# UNITED STATES PATENT AND TRADEMARK OFFICE

APPLICATION NO.	FILING DATE	FIRST NAMED INVENTOR	ATTORNEY DOCKET NO.	CONFIRMATION NO.
10/613,605	07/03/2003	David DeRogatis	RAILWA 3.0-001	7300
23562 7590 01/16/2007 BAKER & MCKENZIE LLP PATENT DEPARTMENT 2001 ROSS AVENUE SUITE 2300 DALLAS, TX 75201			EXAMINER GARCIA, ERNESTO	
			ART UNIT 3679	PAPER NUMBER
SHORTENED STATUTORY PERIOD OF RESPONSE		MAIL DATE	DELIVERY MODE	
3 MONTHS		01/16/2007	PAPER

## **DETAILED ACTION**

Abukawa, 5,392,582

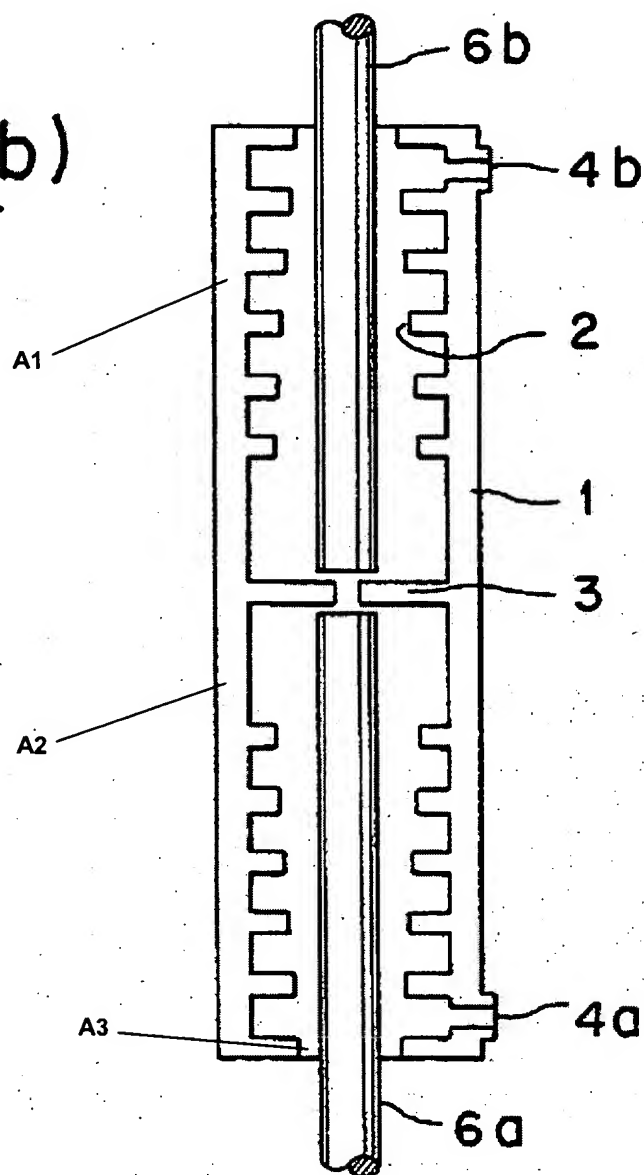
Regarding claim 1, Abukawa discloses, in Figure 6a, a plug fastener 1 comprising a first engaging portion **A1** (see marked-up attachment) and a second engaging portion **A2**. The first engaging portion **A1** has first ridges **2**. The second engaging portion **A2** has second ridges **2**. The first ridges **2** and the second ridges **2** extend parallel with respect to each other. An aperture **A3** extends through the plug fastener 1. The first ridges **2** and the second ridges **2** are concentric with respect to the aperture **A3**.

Regarding claim 7, pairs of corresponding ridges **2** from the first portion and the second portion provide symmetrical decreasing widths of the plug fastener away from an equator of the plug fastener perpendicular to the aperture **A3** (see Figure 6a).

Regarding claim 49, at least one of the first ridges **2** comprises an end slanted in a direction opposite than a direction an end of at least one of the second ridges **2** is slanted, and at least one of the second ridges **2** comprises an end slanted in a direction opposite than the direction the end of the at least one of the first ridges is slanted (see Figure 4).

Regarding claim 54, the plug fastener further comprising a fastening device **6b** disposed within the aperture **A3**.

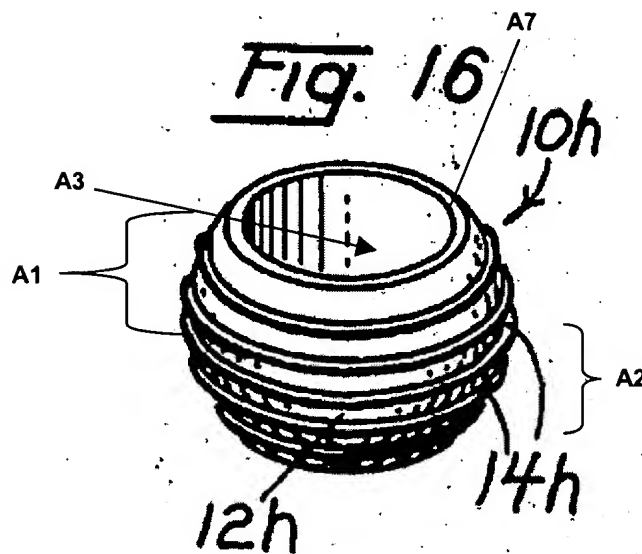
The drawings were received on November 28, 2006. These drawings are not acceptable because they introduce new matter. Note that the original drawings show a distinct plug fastener in Figures 13A, 14, and 15-17 (see attachment for elected species) than the drawings filed on November 28, 2006 and February 4, 2004, which have not been approved. Note that the differences between the corresponding plug fasteners are drastic. The original filed drawings show the plug fastener in Figures 15-17 with ridges projecting out of the exterior surface of the sphere, as also described at original paragraph 055, lines 11-15. The current Figures 15, 15A-15D, 16 and 21 now show the ridges being internal of the exterior surface of the sphere. Further, the ridges on the original plug fasteners in Figures 13A and 14 show the ridges being triangular and pointing toward each other from either portion. The new Figures 13A and 14A show the ridges being straight and not triangular.

Regarding claims 1 and 57, the recitations "ridges comprising parallel rectilinear sidewalls" in claim 1, lines 2 and 3, and claim 57, lines 4 and 7, are not supported by the written description requirement. Note that although the current drawings show this feature, the applicants cannot rely on these drawings to find support since the current

drawings show different types of ridges as compared to the original drawings filed with the application on July 7, 2003. See attachment. Note that originally, the ridges were triangular and the ridges of a first portion were directed towards the ridges of a second portion. Accordingly, these new limitations do not comply with the written description.

Regarding claim 61, the recitation "ends of the first and second ridges are tapered respectively from the first and second openings towards a maximum diameter of the plug fastener" in lines 1-3 is not supported by the original disclosure. Note that the original filed drawings contained triangular pointed ends and thus not tapered ends. See attachment. Accordingly, this limitation does not comply with the written description.

FIG. 16

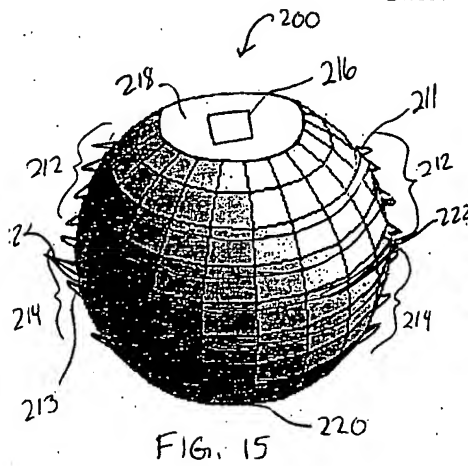
Regarding claim 1, Rapata discloses, in Figure 16, a plug fastener **10d** comprising a first engaging portion **A1** (see marked-up attachment) and a second engaging portion **A2**. The first engaging portion **A1** has first ridges **14h**. The second engaging portion **A2** has second ridges **14h**. The first ridges **14h** are slanted with respect to the second ridges **14h**. An aperture **A3** extends through the plug fastener. The first ridges **14h** and the second ridges **14h** are concentric with respect to the aperture **A3**. However, Rapata fails to disclose the first ridges and the second ridges comprising parallel rectilinear sidewalls and the sidewalls extending parallel with respect to one another. Lautenschlager teaches, in Figure 3, first ridges and second ridges **20** having parallel rectilinear sidewalls extending parallel with respect to one another as part of a design choice for storing spring force so that the ridges return into their initial flat state (col. 4, lines 62-64). Therefore, as taught by Lautenschlager, it would have been obvious to one of ordinary skill in the art at the time the invention was made to replace the ridges of Harder with any known ridge design so that the ridges return to their initial flat state using rectilinear sidewalls extending parallel with respect to one another.

Regarding claim 57, Rapata discloses in Figure 16, a substantially plug fastener **10h** comprising an aperture **A3**, a first hemisphere **A1**, and a second hemisphere **A2**. The aperture **A3** extends through the plug fastener and has a first opening **A7** and a second opening (below opposite to **A7**). The first hemisphere **A1** has first ridges **14d** concentric and orthogonal with respect to the aperture **A3**. The first hemisphere **A1** includes the first opening **A7**. The second hemisphere **A2** has second ridges **14h** concentric and orthogonal with respect to the aperture **A3**. The second hemisphere **A2** includes the second opening. Ends of the first ridges **14h** and the second ridges **14h** are tapered respectively from the first opening and the second opening towards a maximum diameter of the fastener **10h** (note that the ridges are curved such that half of the curved is tapered towards the maximum diameter). However, Rapata fails to disclose the first ridges and the second ridges comprising parallel rectilinear sidewalls and the sidewalls extending parallel with respect to one another. Lautenschlager teaches, in Figure 3, first ridges and second ridges **20** having parallel rectilinear sidewalls extending parallel with respect to one another as part of a design choice for
